STAFF REPORT: FEBRUARY 12, 2024 MEETING PREPARED BY: A. DYE

**APPLICATION NUMBER:** HDC2024-00674

**ADDRESS: 6134 SECOND AVENUE**

**SCOPE**: INFILL WINDOWS, ERECT RAMP

This view shows metal panels that were placed within the basement window openings.

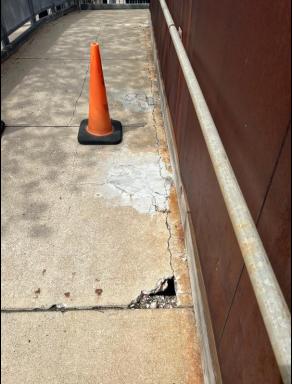
- have fixed replacement windows).
- As a new ramp is proposed in the same location as the previous ramp, staff agrees with the applicant's assessment that continued coverage of the window openings with panels would allow consistent water infiltration that could, over time, severely damage the foundation and walls of the building. The applicant's suggestion to brick in the openings, like the method used at one of the second floor window openings, would create a more weather-tight building while leaving the openings intact for the future installation of windows should the ramp be removed.

Plan view of the ramp and stairs.

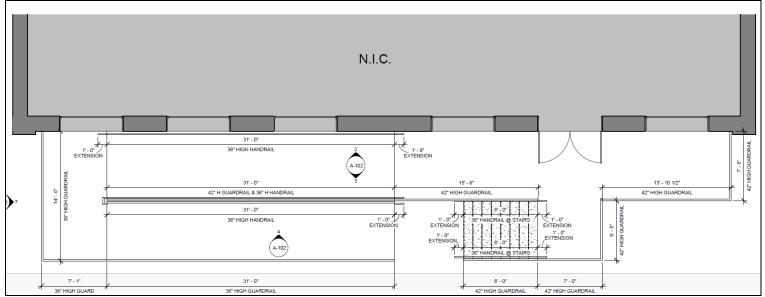
• It is staff's opinion the new ramp's minimal design is compatible with the massing, scale and features of the historic building. Also, the installation and future removal of the ramp will not destroy materials that characterize the property.

Notes on two pages of the submitted documents reference the infill of the basement windows.

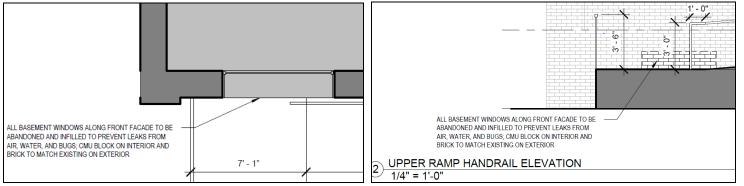
■ The drawings should note the matching brick within the windows openings will be recessed 1-3 inches from the exterior walls.

■ The following note will be added to pages A-101 A-102: Matching brick installed within the window openings will be recessed 1-3 inches from the exterior walls.
